National Grid Electricity Transmission's Enhancing Pre-existing Infrastructure project in the Snowdonia National Park

Subject	Details
Publication date:	26 May 2022
Response deadline:	24 June 2022
Contact	Anna Kulhavy, Senior Regulatory Economist
Team:	RIIO Operations: Response and Monitoring
Email:	Anna.Kulhavy@ofgem.gov.uk

We¹ are consulting on our assessment of a funding request by National Grid Electricity Transmission (NGET) to deliver a new Enhancing Pre-existing Infrastructure (EPI) output to reduce visual amenity impacts on the western edge of the Snowdonia National Park. We would like views from people with an interest in electricity transmission networks. We would also welcome responses from other stakeholders and the public.

Figure 1: Section 4ZC.1 of 400kV/132kV overhead line

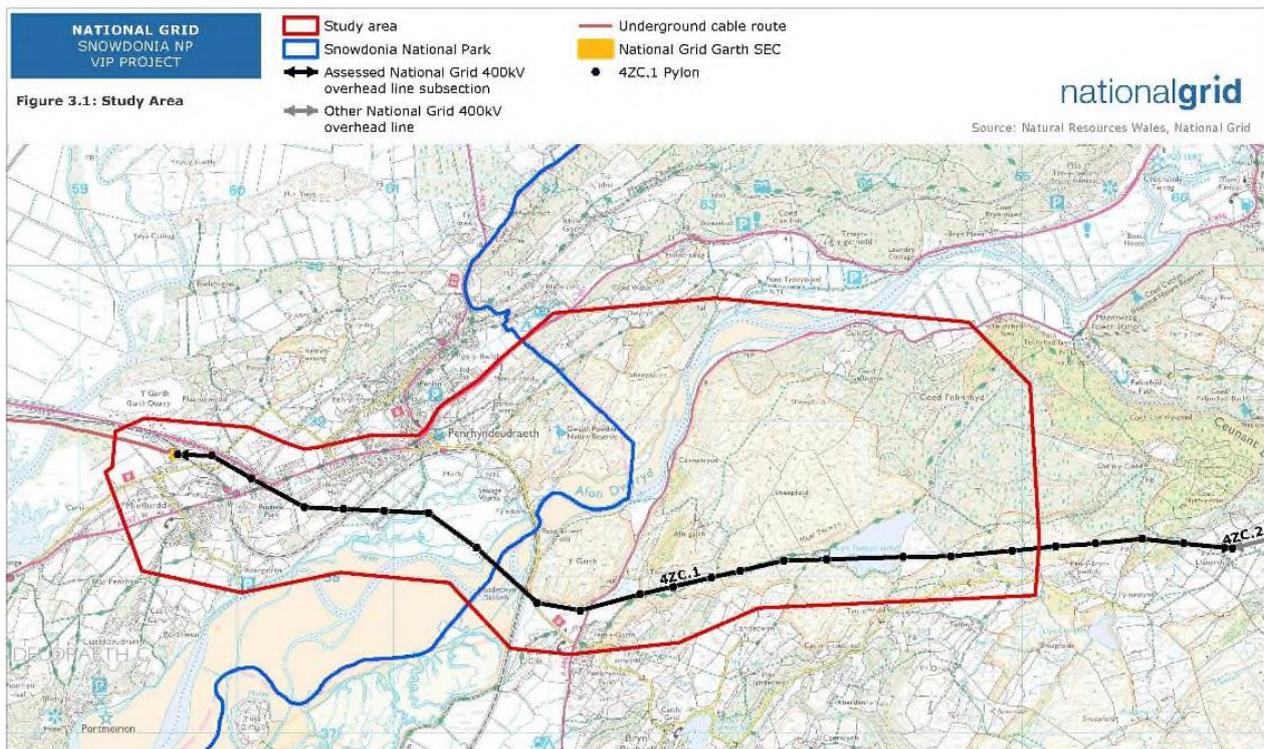
3.4. The 4ZC 400kV overhead line connects the Pentir 400kV and Trawsfynydd 400kV substations in north Wales. The Snowdonia EPI project focuses a section of the line, 4ZC.1, which runs from the Garth Sealing End Compound (SEC) near the village of Minffordd (east of Porthmadog) and across the Dwyryd Estuary to the western edge of the national park. It then

continues past the small settlement of Cilfor and up towards the summit of Moel Tecwyn (see figure 1).

3.6. NGET has assessed the impacts of 4ZC.1 and the expected benefits of removing the line section on the western edge of the Snowdonia National Park. This is summarised below.

Figure 2: Indicative cable tunnel route (red dashed line) and existing overhead line (green line with dots)

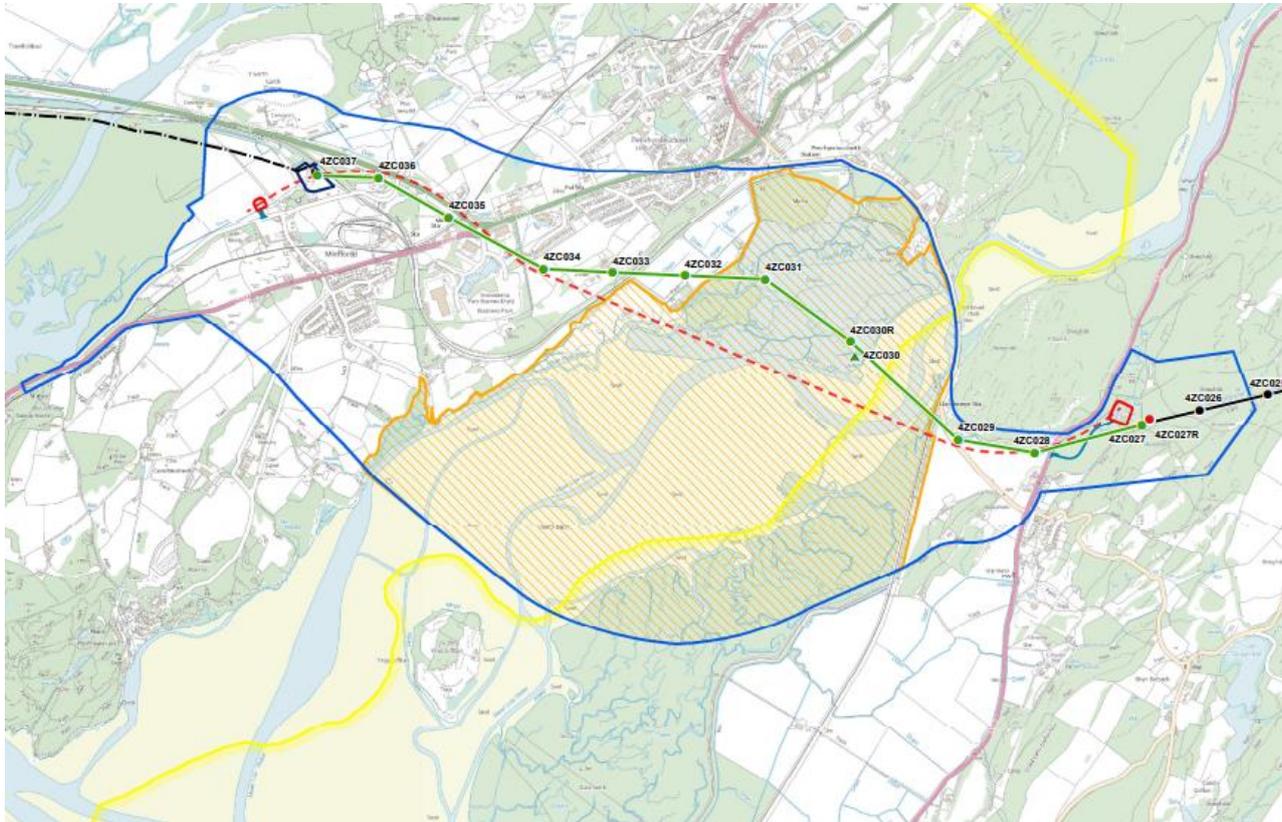
4.20. The Snowdonia EPI project will involve replacing a section of overhead line that crosses the Dwyryd Estuary with an underground cable in a tunnel that runs from the existing Garth Sealing End Compound in the west to just beyond the settlement of Cilfor in the east. In addition, a tunnel head house and sealing end compound will be built at the eastern end of the tunnel to connect the new cables to the remaining overhead line beyond Cilfor that runs to the Trawsfynydd 400kV substation. A tunnel head house would also be required at the western end of the tunnel near the Garth SEC (see figure 2).

4.29. Pylons 4ZC28 – 4ZC37 (see figure 2 above) will be removed including the overhead line spanning across them. Pylon 4ZC27 at the east end of the tunnel is to be replaced with a terminal pylon. The foundations for pylons 4ZC27 - 4ZC37 will be removed to a depth of 1.4 metres below ground excluding pylons 4ZC30R, 4ZC030 AND 4ZC031, which are located in the estuary. NGET will attempt to remove 4ZC30R’s piled foundations in full. If this is not possible, they will be removed to two metres below ground level. The foundations for 4ZC30 will have the whole of the pile caps and piles removed as far as is reasonably practicable and 4ZC31’s foundations will be removed to 3.75 metres below ground level as per an agreement with Natural Resources Wales.
